ADDENDUM #02

209 N John St., Highland Twp., MI 48357

COMM. NO. 26044

ADDENDUM NO. 02

LOADBEARING WOOD STUD PARTITION - 1 HOUR

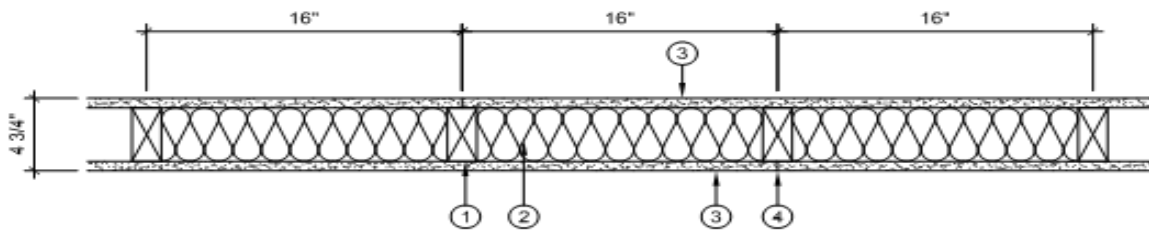
| 03 | CLARIFICATION: UL design number rated wall and ceiling assembly construction requirements clarified via. manufacturer data sheets from National Gypsum pertaining to U305 and I504. Refer to the following two pages. |

1. MIN. 2x4 WOOD STUDS 16" O.C.
2. 3-1/2" GLASS FIBER INSULATION
3. 5/8" GOLD BOND FIRE-SHIELD GYPSUM BOARD (FSW, FSW-6, FSK) APPLIED VERTICALLY OR HORIZONTALLY AND FASTENED WITH 1-7/8" 6d NAILS 7" O.C. OR 1-1/4" TYPE W SCREWS 8" O.C. VERTICAL JOINTS CENTERED OVER STUDS AND STAGGERED 16" FROM OPPOSITE SIDE.
4. JOINT TAPE AND COMPOUND OVER JOINTS AND FASTENER HEADS (OPTIONAL WHEN SQUARE EDGE BOARD IS USED)

UL DESIGN: U305

1 HOUR STEEL STUD CEILING ASSEMBLY

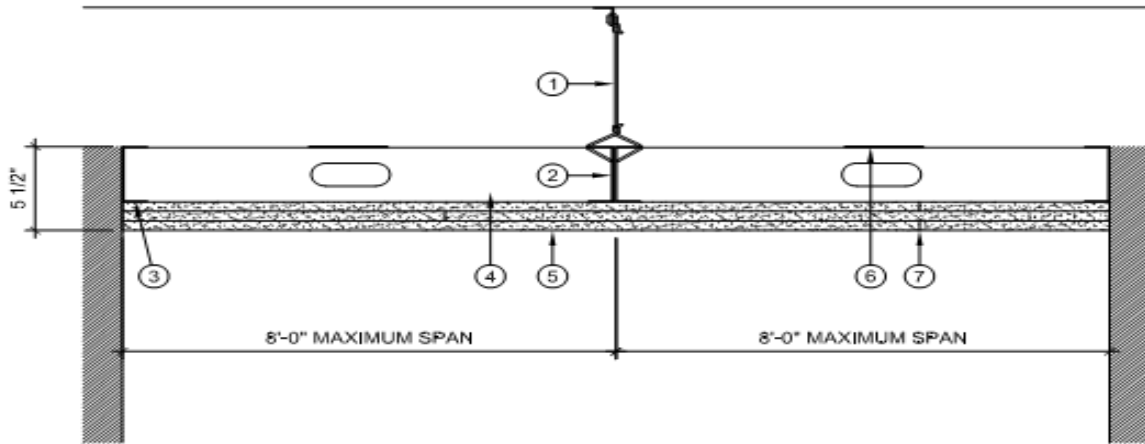
| 02 | CHANGE: UL design number has been corrected for the rated ceiling assembly at view 2/A3. |

1. MIN. 8 GAUGE HANGER WIRE 24" O.C.
2. MIN. 3-5/8" 20 GAUGE C-TRACKS FASTENED BACK TO BACK WITH 1/2" TYPE S SCREWS SPACED 24 O.C. ALONG CENTERLINE. BUTT JOINTS STAGGERED 12" AND FASTENED WITH TWO SCREWS, TOP AND BOTTOM, ON EACH SIDE OF BUTT JOINT

3. MIN. 3-5/8" 20 GAUGE C-TRACKS FASTENED TO FIRE-RATED SUPPORTING STRUCTURE WITH FASTENERS SPACED MAX. 24 O.C. ALONG TOP AND BOTTOM OF VERTICAL LEG
4. MIN. 20 GAUGE 3-5/8" STEEL STUDS 16" O.C. FASTENED TO TOP AND BOTTOM LEG OF C-TRACKS WITH 3/8" PAN-HEAD SCREWS

5. THREE LAYERS 5/8" FIRE-SHIELD GYPSUM BOARD (FSW, FSW-6) APPLIED PERPENDICULAR TO STUDS. BASE LAYER FASTENED TO STUDS AND TRACKS WITH 1" TYPE S SCREWS 16" O.C. SECOND LAYER FASTENED WITH 1-5/8" SCREWS 16" O.C. FACE LAYER FASTENED WITH 2-1/4" SCREWS 12" O.C. JOINTS STAGGERED MIN. 16" FROM ADJACENT LAYERS

6. MIN. 20 GAUGE 4" STEEL STRAP LOCATED AT CENTER SPAN AND FASTENED TO EACH STUD WITH ONE 3/8" PAN-HEAD SCREW. STRAPS OVERLAPPED ONE STUD BAY AT SPLICE LOCATIONS

7. JOINT TAPE AND COMPOUND OVER JOINTS AND FASTENER HEADS (OPTIONAL)

UL DESIGN: I504, GA FILE: HM 7101
